June 13, 2025

City of Aurora
Planning Division

RE: Debreselam Medhanealem (Savior Of The World) Church - Site Plan
Application Number: DA-2386-00, Case Number: 2024-6033-00
3rd Review Applicant Response Letter

SITE PLAN

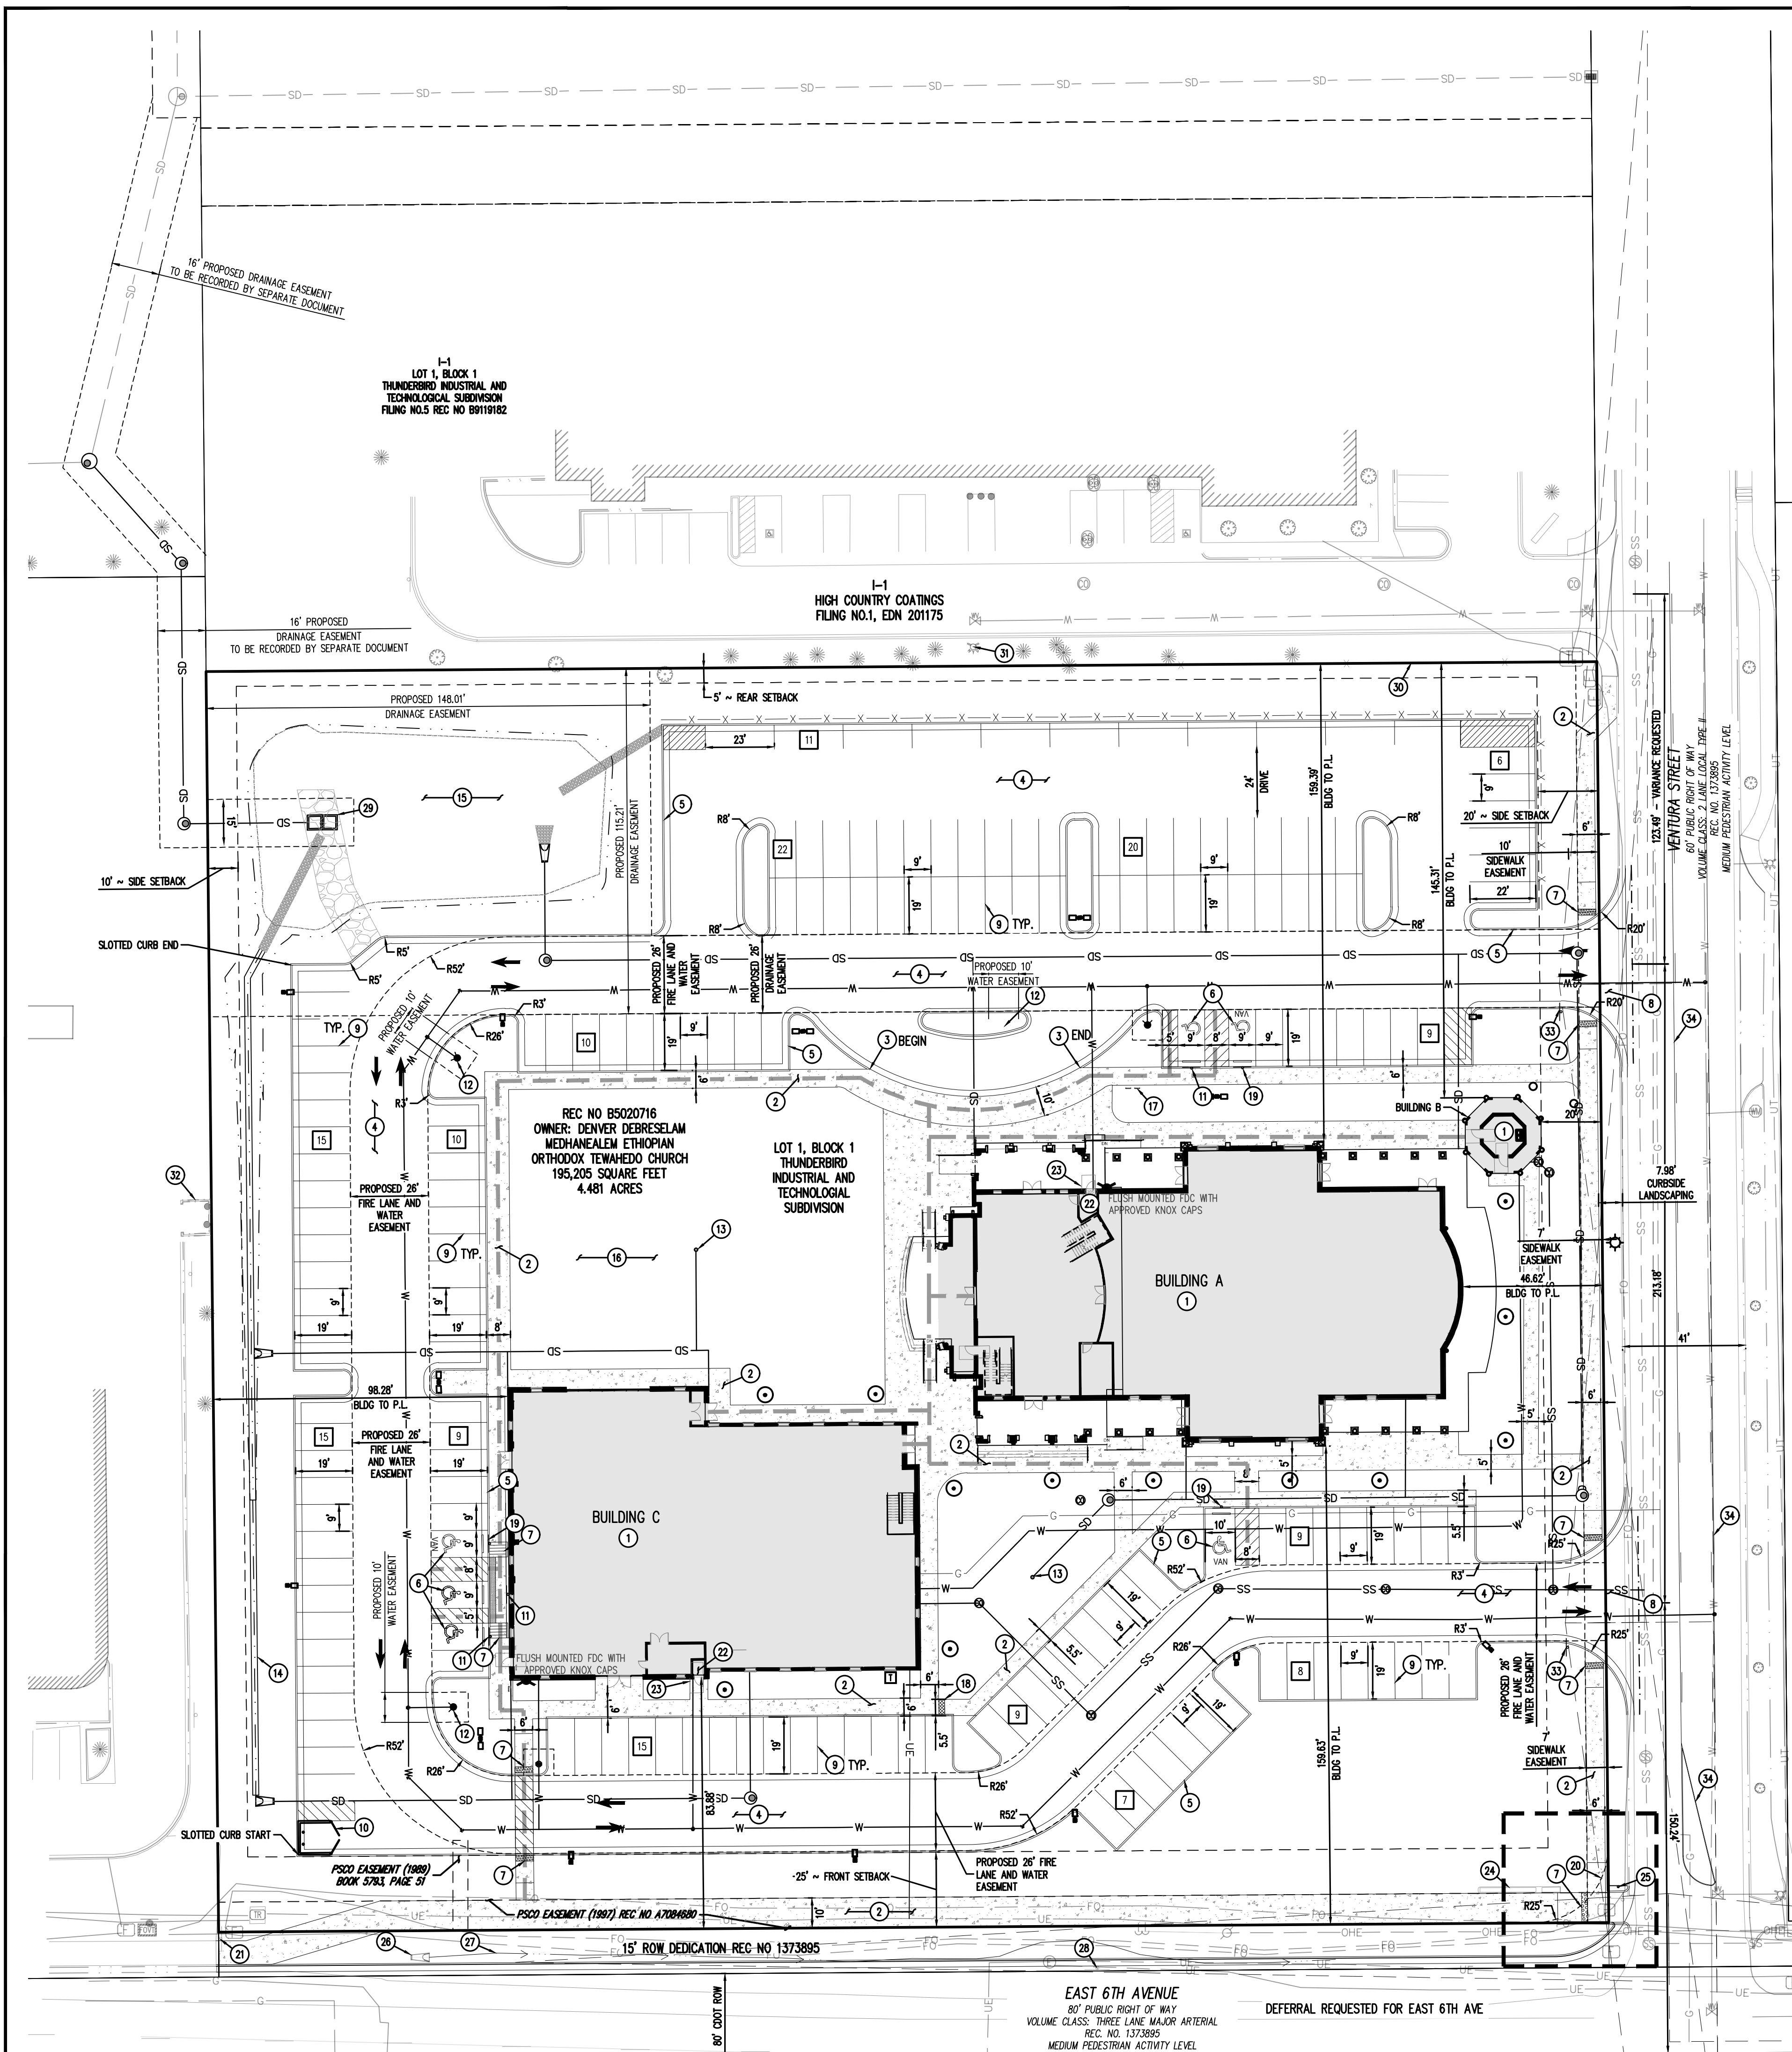
- 6C. Two turn lane striping is being evaluated for Ventura. This could be a change during civil plans.

- 7A. Please identify all public and main entrances in Building A and Building C. Make sure at least 60% of all public entrances are accessible. TYP
Galloway Response: All entrances have been identified and labeled in the site legend.

- 7B. Knox boxes should be located at main entrance to building and fire riser room.
Galloway Response: Knox box locations have been updated to comply with this standard.

- 7C. Repeat Comment: Accessible route must connect to trash enclosure. TYP
Galloway Response: Accessible route has been shown to connect to the trash enclosure.

Galloway Response: *Acknowledged.*
